CITY PLAN COMMISSION**THURSDAY, AUGUST 8, 2024****FILE NUMBER:** S234-148**SENIOR PLANNER:** Hema Sharma**LOCATION:** Singleton Boulevard at Normandy Brook Road, northeast corner**DATE FILED:** July 10, 2024**ZONING:** PD 508 (Tract 13A)**PD LINK:** <https://dallascityhall.com/departments/city-attorney/Articles/PDF/Article%20508.pdf>**CITY COUNCIL DISTRICT:** 6**SIZE OF REQUEST:** 0.854 -acres**APPLICANT/OWNER:** James Armstrong III; Greenleaf Ventures, LLC

REQUEST: An application to replat a 0.854-acre tract of land containing all of Common Area A and Lot 1 in City Block 16/7135 to create one 0.346-acre lot, one 0.436-acre lot and one Common Area on property located on Singleton Boulevard at Normandy Brook Road, northeast corner.

PRELIMINARY PLAT
SINGLETON VILLAS ADDITION
LOTS 1A-R & 1B-R, AND COMMON AREA A
BLOCK 167133
 BEING A REPLAT OF COMMON AREA A, AND LOT 1, BLOCK 167135, OF THE SINGLETON VILLAS ADDITION SITUATED IN THE ENCOCH HORTON SURVEY, ABSTRACT NO. 604, CITY OF DALLAS, DALLAS COUNTY, TEXAS
 FILE NO. S234-148

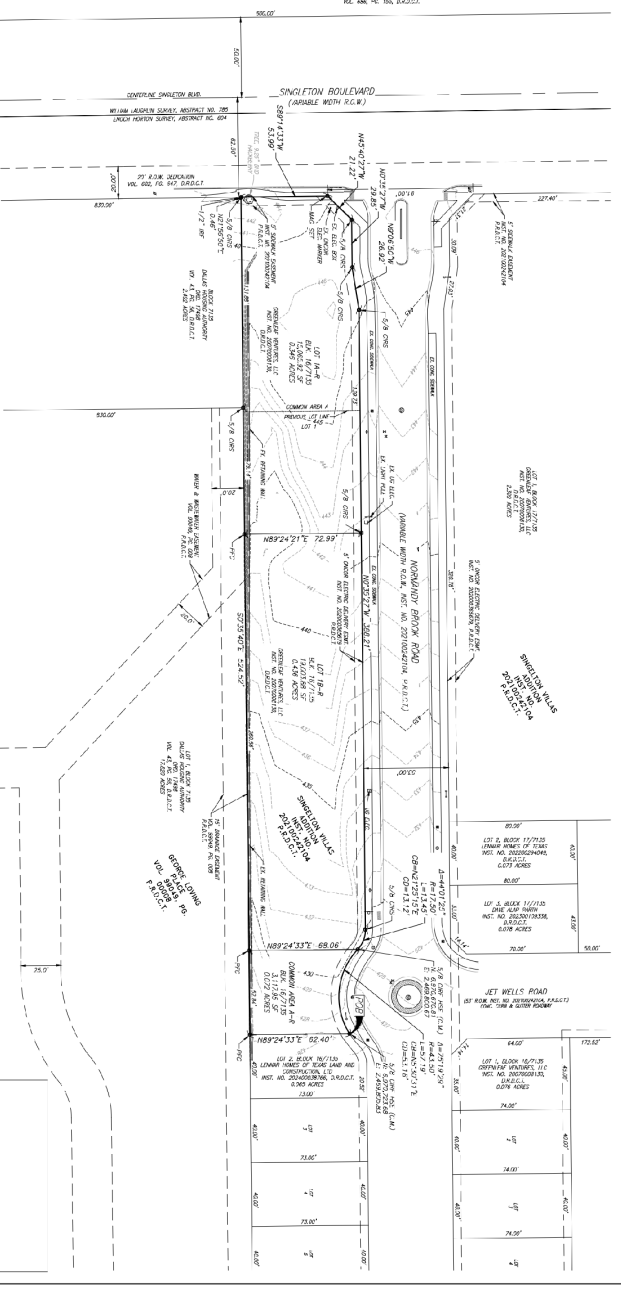
16. On the final plat, dedicate 28 feet of right-of-way (via fee simple or Street Easement) from the established center line of Normandy Brook Road. *Section 51A 8.602(c) 51A 8.604(c)*

17. Prior to final plat, submit a completed final plat checklist and all supporting documents.
18. On the final plat, show how all adjoining right-of-way was created. Section 51A-8.403(a)(1)(A)(xxii).
19. On the final plat, show distances/width across all adjoining right-of-way. Platting Guidelines.
20. On the final plat, show recording information on all existing easements within 150 feet of the property.
21. On the final plat, show all additions or tracts of land within 150 feet of the property with recording information. Platting Guidelines.
22. On the final plat, chose a new or different plat name. Platting Guidelines.

24. On the final plat, change “Singleton Boulevard” to “Singleton Boulevard (FKA Eagle Ford Road”. Section 51A-8.403(a)(1)(A)(xii).
25. On the final plat, identify the property as Lots 1A & 1B and CA “A”in City Block 16/7135.
